SERVICE BULLETIN

#0002

RELEASE DATE: 14 August 2014
EFFECTIVE DATE: 14 August 2014
SUBJECT: Reinforcement of the Upper Join between the Centre and Rear Fuselages
MODELS AFFECTED: Sling 4 serial numbers 001 to 060, inclusive
COMPLIANCE TIME: Before or during next scheduled maintenance ("MPI")
PURPOSE:

the AIRPLANE FACTORY	
DESCRIPTION	pg
REAR FUSELAGE FRONT EDGE HOLES	
Sheet 4	Revision
Date: 2014/08/14	Revision

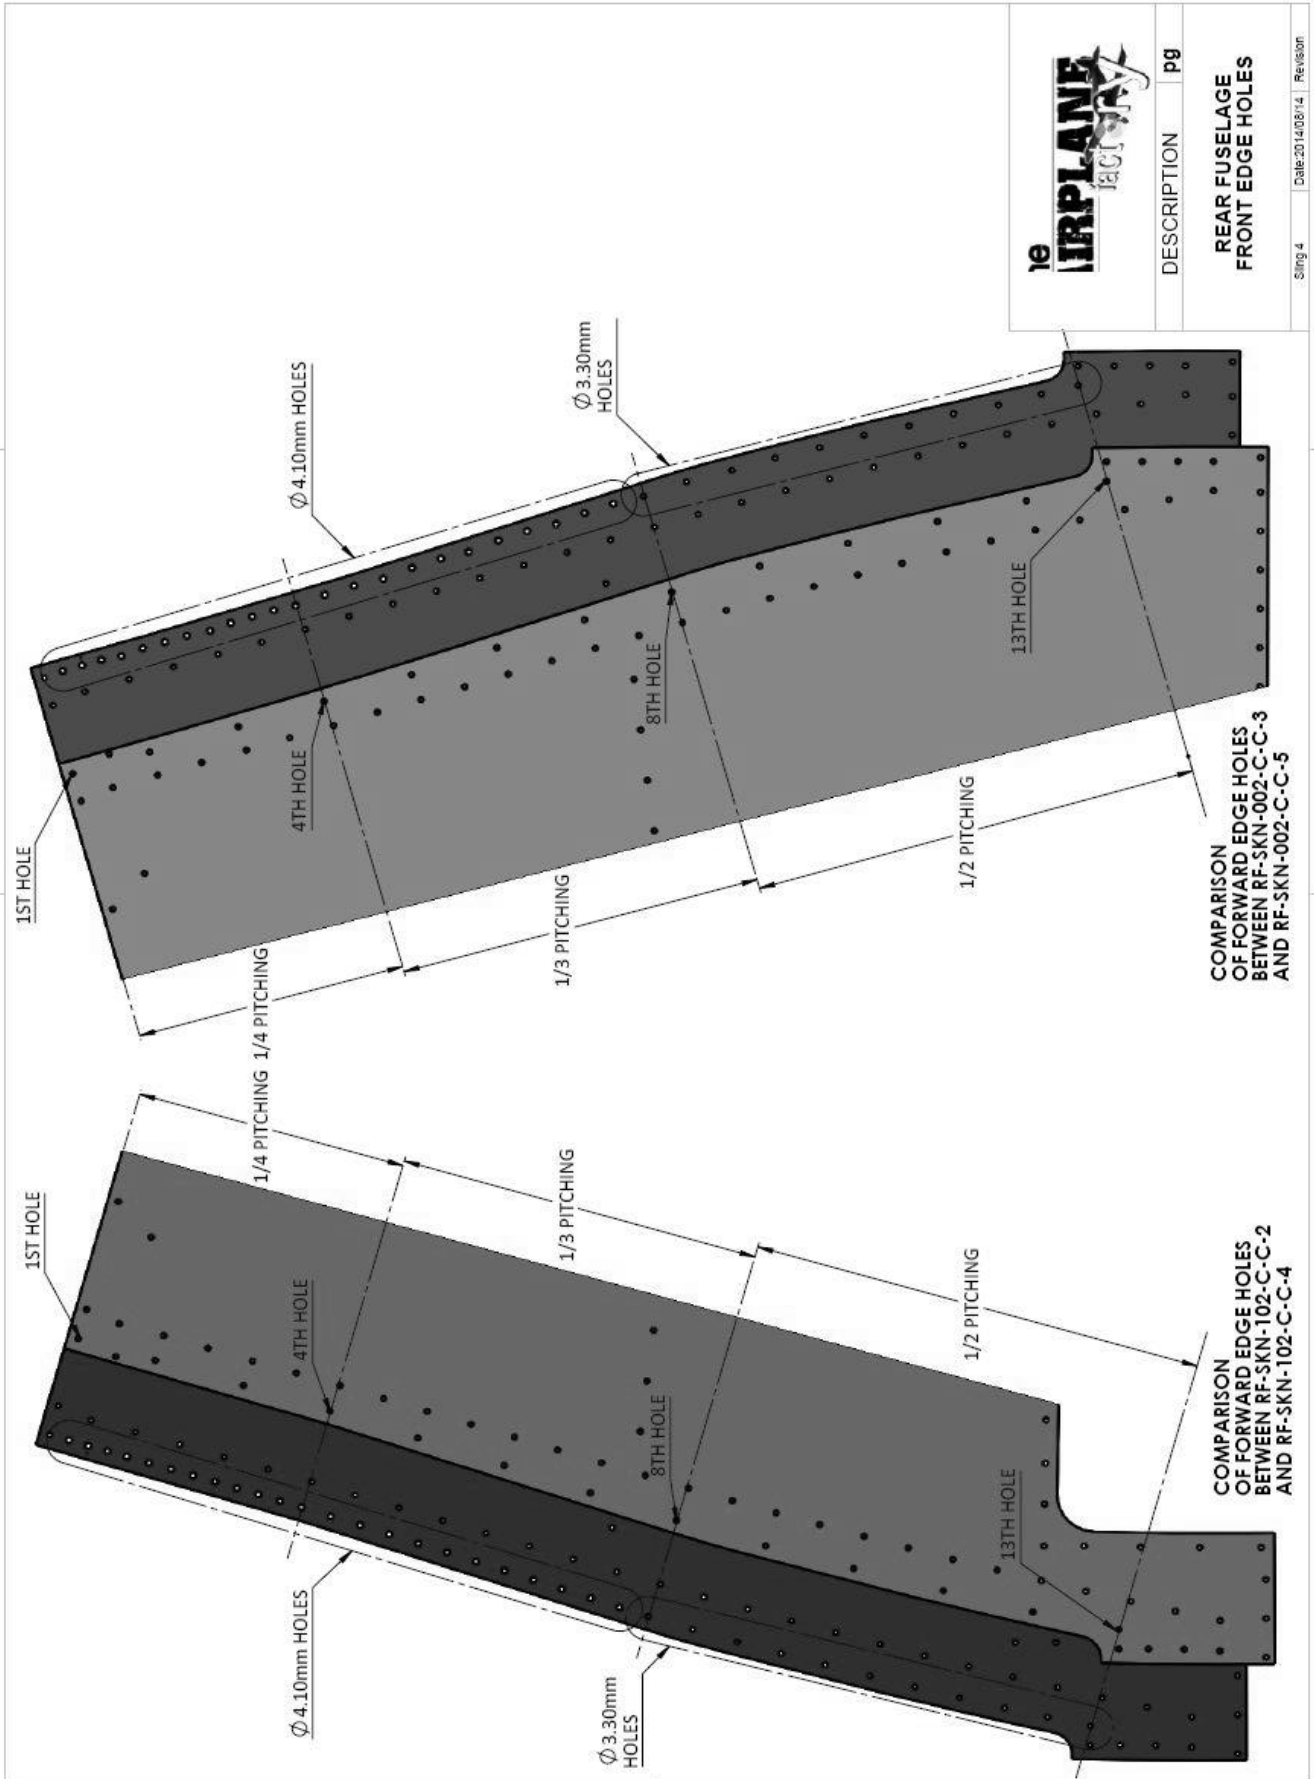
3. The affected skins are those on the upper rear fuselage and have part numbers RF-SKN-102-C-C-2 (left side) and RF-SKN-002-C-C-3 (right side) respectively. The new skins have part numbers RF-SKN-102-C-C-4 (left side) and RF-SKN-002-C-C-5 (right side) respectively.

5. Use the pen or pencil to draw a straight line on the curved skin surface of the rear fuselage upper front skin edge that passes through the existing rivet line connecting the skin to the rear, upper lip of the composite canopy frame. Ensure that the curve is the same distance from the edge of the skin along its entire length.

6. Use a ruler and a pen to mark off the points along the curve where the new rivets will be inserted. One quarter pitching is required between the first and fourth holes counted down from the parachute cable tray. One third pitching is required between the fourth and eighth holes. Finally, half pitching is required between the eighth and thirteenth holes. Note: The first hole is covered by the parachute covering skin and it is unnecessary to remove this skin. Simply adjust the pitching in a practical fashion for the spacing of the first hole as close as practically possible to the parachute skin edge.

7. Use a 4.0 mm ($\text{Ø}5/32''$) diameter drill bit to drill the holes marked above the eighth hole and a 3.2 mm ($1/8''$) diameter drill bit to drill those below. Drill through the rear fuselage skins and the composite canopy lip in such a fashion that a correctly sized rivet may be fully inserted so that the rivet flange lies flush with the aluminium rear fuselage skin.

9. Now that the new holes have been drilled and riveted, certain of the original 3.2 mm rivets should be removed so that they may be replaced with 4.0 mm rivets – Note that this is only required for the top seven rivets. (In addition, if the first rivet is covered by the parachute covering skin then this rivet may be left as it is and need not be replaced). The eighth rivet and all rivets below it remains 3.2 mm diameter rivets.

10. Open the holes by drilling with a 4 mm ($5/32''$) diameter drill bit.
11. Fit and then pull the remaining 4.0 mm x 10 ($5/32''$ x $3/8''$) multi-grip blind rivets with the pneumatic or hand operated pull riveter whilst ensuring that the skin lies flush against the composite.
